Work Order ID 119104

Item ID: D212-664-201

Item Name: Aft Crosstube - High

DRAWING NO. D212-664-241	TITLE CROSSTUBE ASSY (205/212 HI AFT)	REV. D	DART AEROSPACE LTD ENGINEERING ORDER		D.E.O. NO. D212-664-241-D-1	SHEET NO. SHEET 1 OF 2	SCALE NTS
DRAWN	CHECKED	MFG. APPR.	APPROVED	DE APPR.			
DATE 11.04.07	DATE 11.04.11	DATE 11.04.12	DATE 11/04/12	DATE 11.04.12

**D212-664-241/-241B
ASSEMBLY DETAIL**

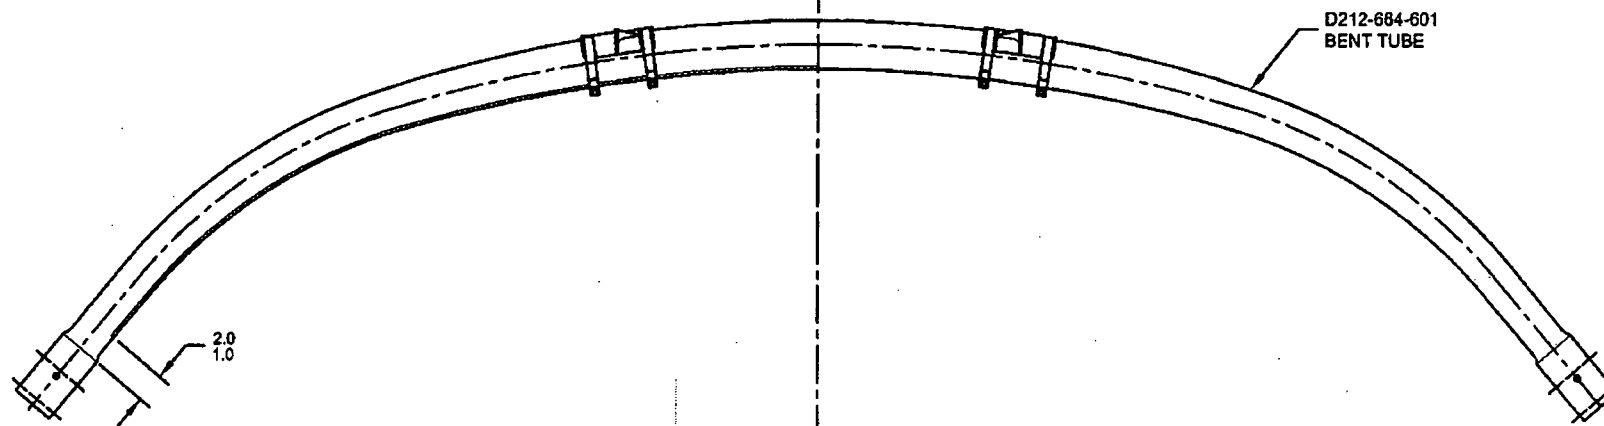
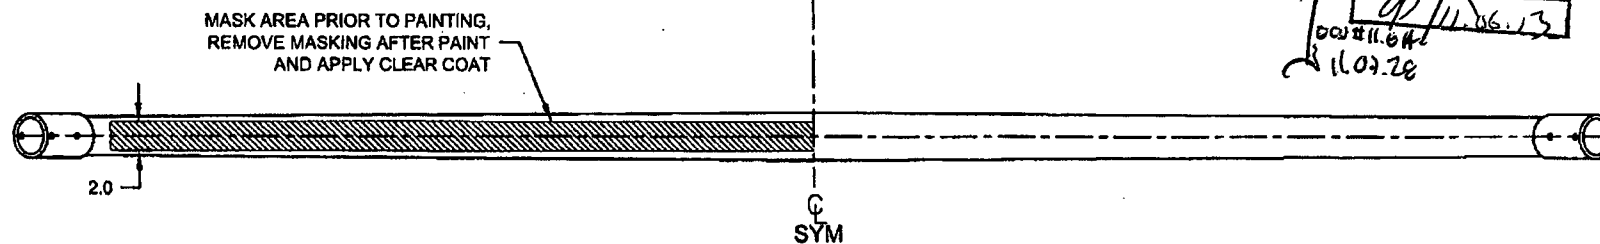
ADD AN INSPECTION WINDOW TO UNDERSIDE OF CROSSTUBE.

NOTES 2 OF SHEET 1 IS AMENDED AS FOLLOWS:

- 2) FINISH: CHEMICAL CONVERSION COAT PER DART QSI 005 4.1
PRIME INSIDE AND OUTSIDE PER DART QSI 005 4.2
MASK UNDERSIDE OF CROSSTUBE AS SHOWN (HATCHED AREA) AND
PAINT OUTSIDE PER DART QSI 005 4.2
REMOVE MASKING AND APPLY CLEAR COAT

FIGURE 1: SUPPORT INSTALLATION

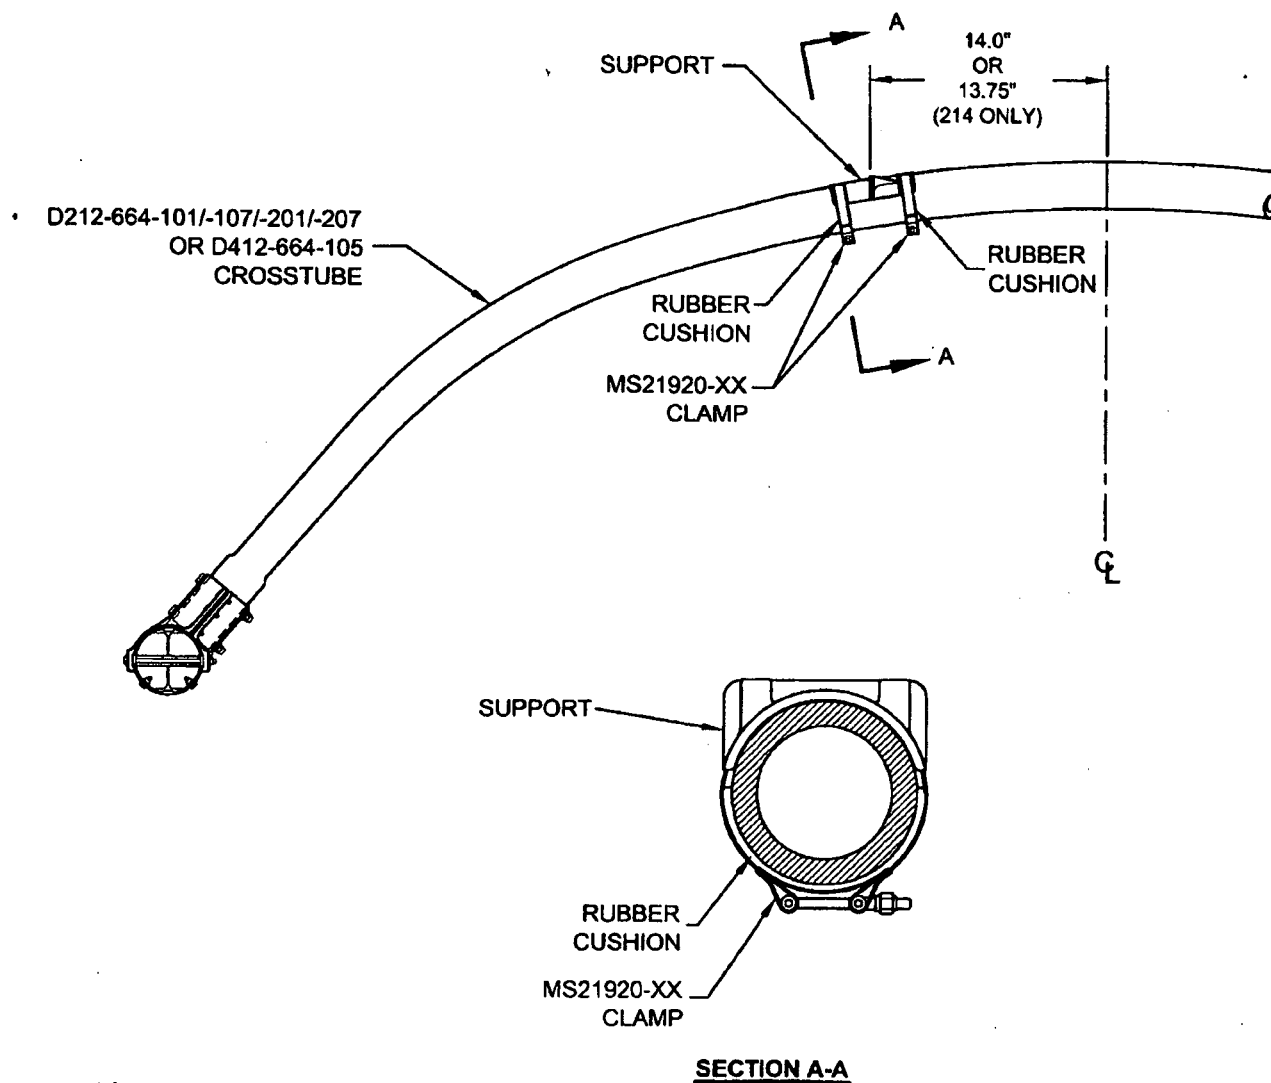
For the crosstubes listed above, section 32.4 of ICA-D212-664 is amended as follows. Use Figure 1 of this service instruction and Figures 32-2 to 32-9 of ICA-D212-664 for further reference. For crosstubes of an earlier change number, it is recommended that if the supports are removed, the supports should be reinstalled using the procedure listed below.

- 32.4.1 Locate the area on the crosstube for installation of support (see Figure 1 of this service instruction). For D212-664-101/-107/-201/-207 and D412-664-105 crosstubes, the outward face of the support tabs should be 14.0" (355mm) from the crosstube center for 204/205/210/412/UH-1 aircraft. For installation on 214B/B-1 aircraft, the outward face of the support tabs should be 13.75" (349mm). Ensure paint finish of crosstube is intact; touch up as required per Chapter 5 (5.3.9) of ICA-D212-664.

- 32.4.2 If present, remove any paint/primer on bottom of supports. Abrade mating surfaces of support and crosstube with 400-grit sandpaper. Saturate a clean cloth with MEK or 4105S Wash'n'Wipe Degreaser or equivalent and wipe until there is no residue.

- 32.4.5 Apply a 0.04" to 0.07" thick layer of Proseal 890 Class B or AMS-S-8802 Class B sealant underneath applicable support and install support as shown in Figure 1 of this service instruction.

- 32.4.6 Install the clamps opposite to crosstube support as shown in section A-A of Figure 1. Install rubber cushions underneath each clamp around the bottom circumference of the crosstube up to the crosstube centerline. Torque clamps 80-100 in·lb (9.0-11.3 Nm). It is acceptable to use smaller or larger sized MS21920-XX clamps than those listed in ICA-D212-664, ensure that after torquing the clamps per this instruction, the nuts are in safety but not bottomed out

CRUSHING OF D212-664-201

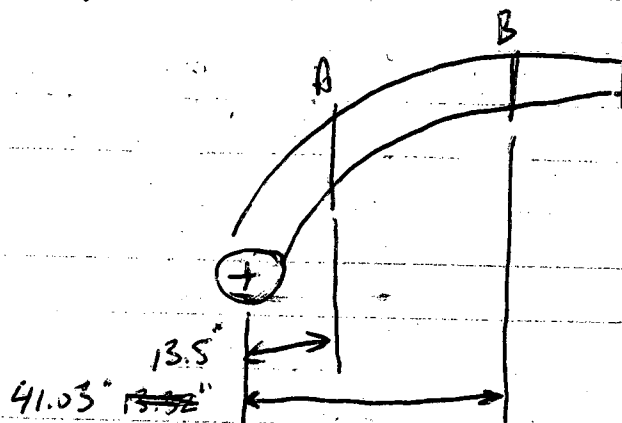
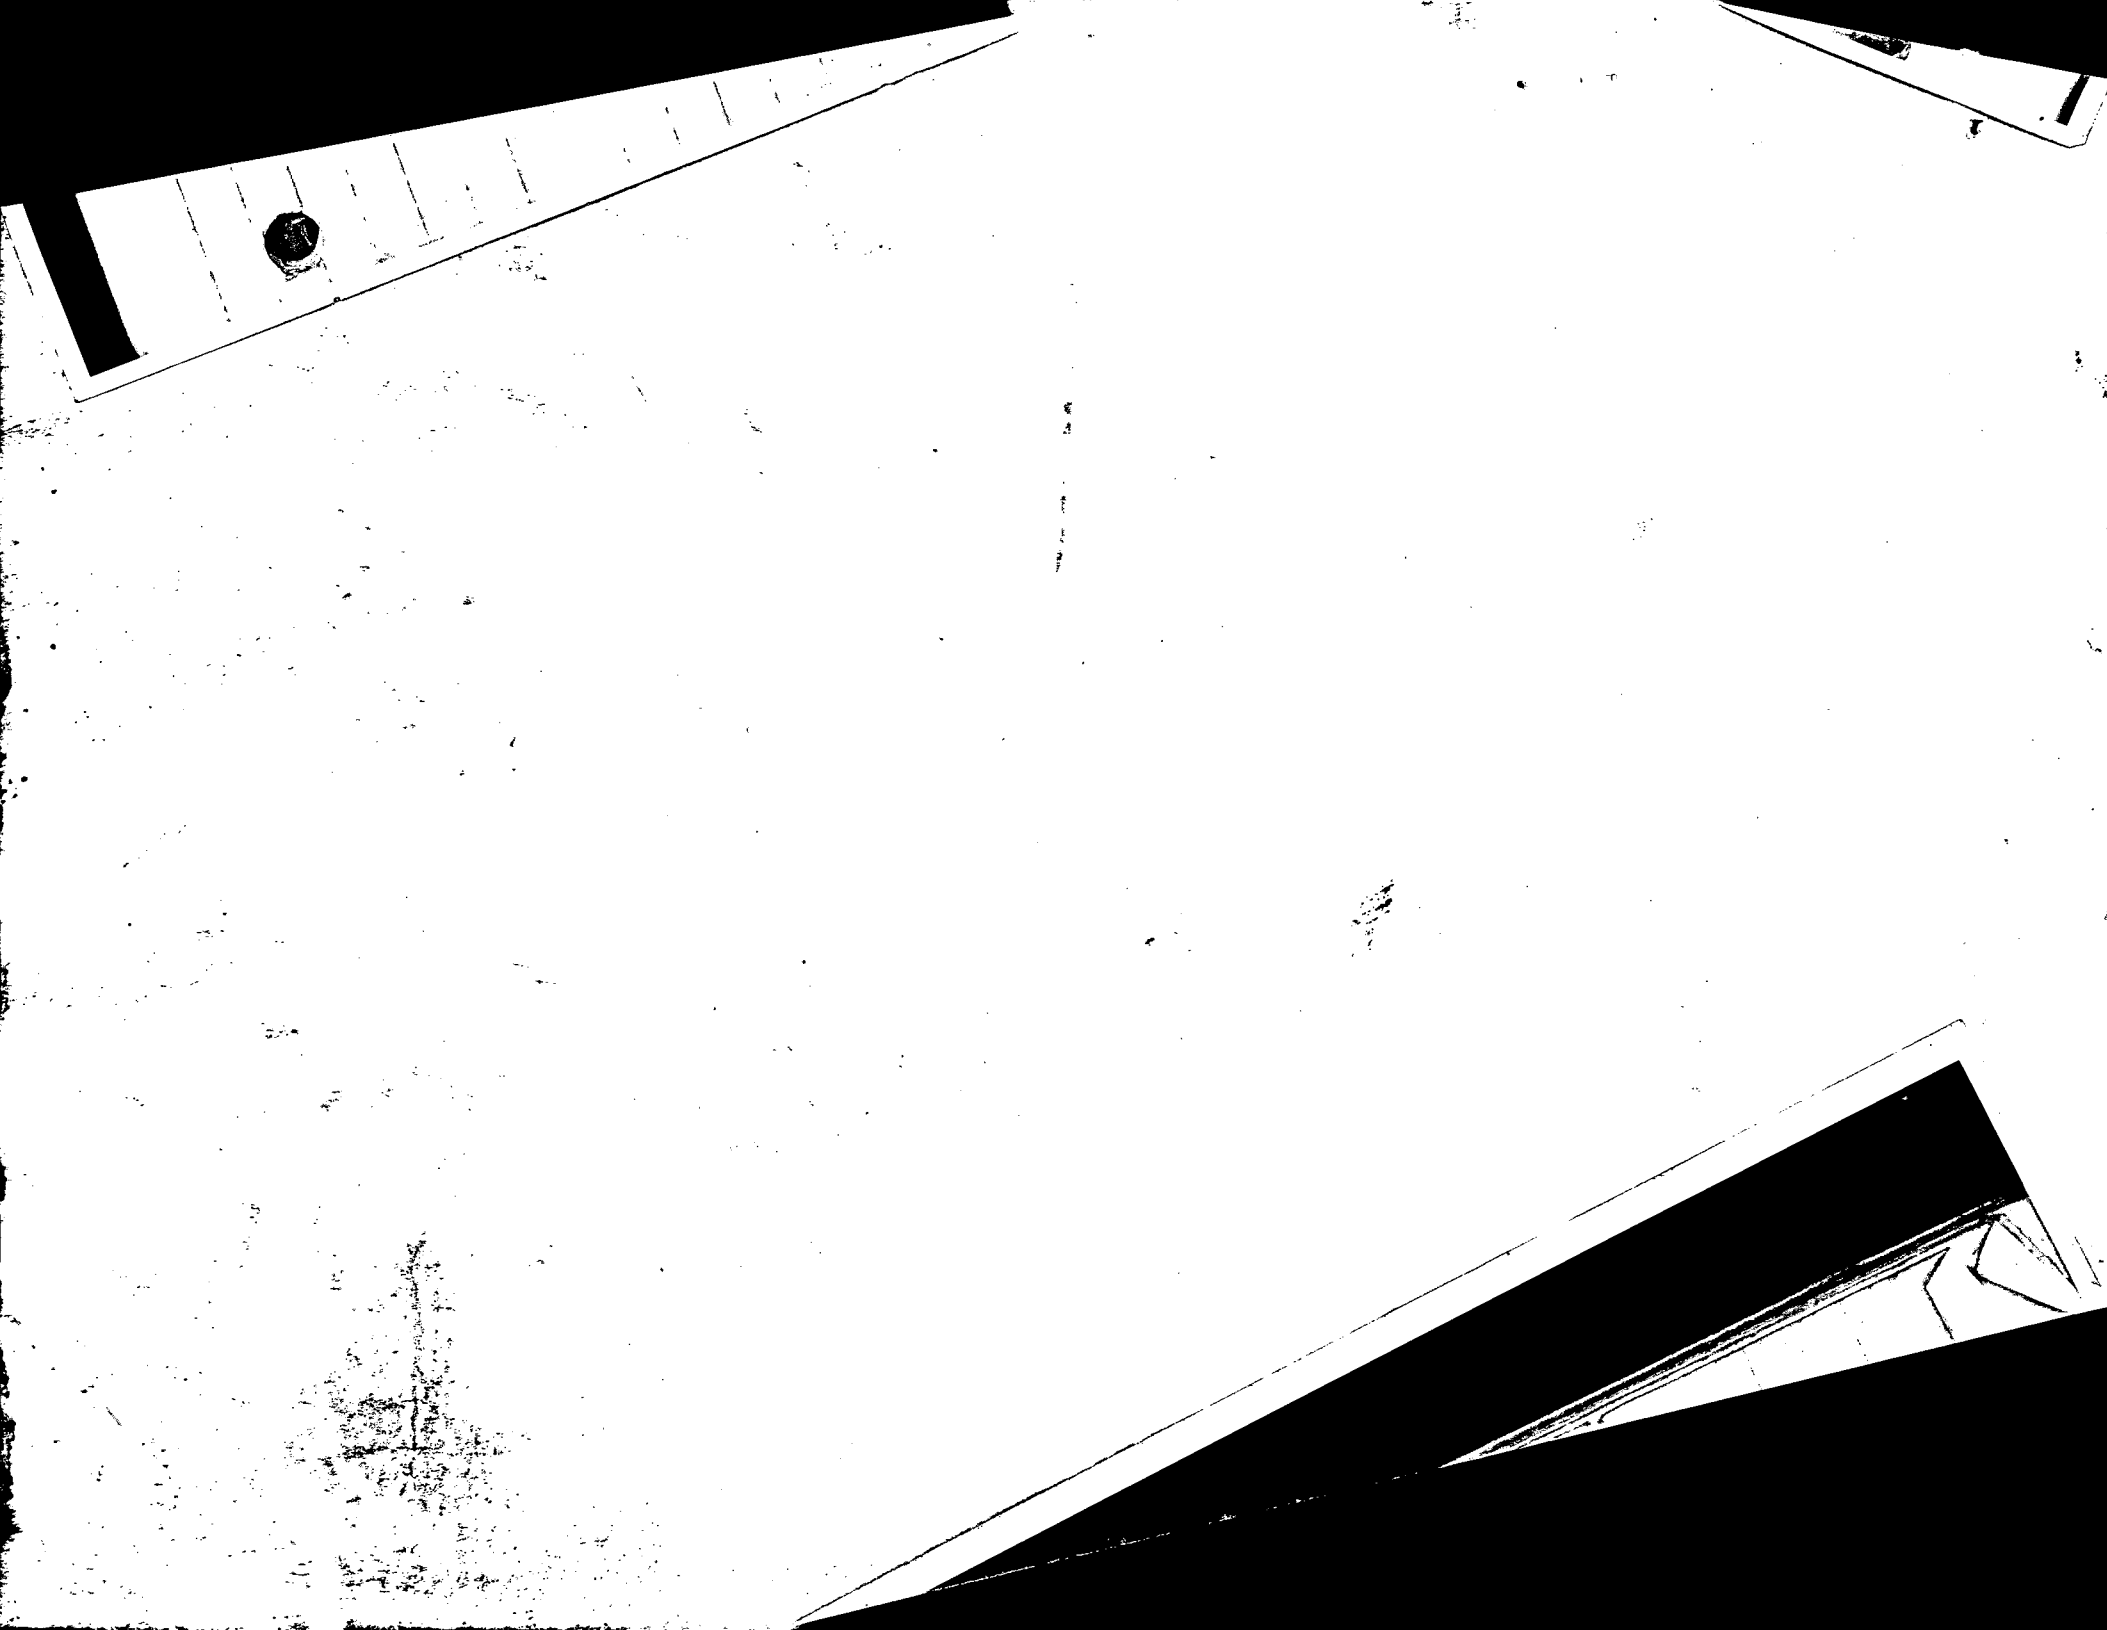
Acceptability of 8% CRUSHING

Point A: $OD1 = 2.548 \text{ in}$ $OD2 = 2.992 \text{ in}$
 $CRUSHING = (2.992 - 2.548) / (2.992 + 2.548) = 8\%$
 $I = 1.476 \text{ in}^4$

Point B: $OD = 3.25 \text{ in}$ $ID = 2.22 \text{ in}$
 $I = 4.284 \text{ in}^4$

A: $F = M/L/I = P \times 13.5 \times 2.548 / 2 \times 1.476 = 11.65 P$
 B: $= P \times 41.03 \times 2.992 / 2 \times 4.284 = 14.32 P$
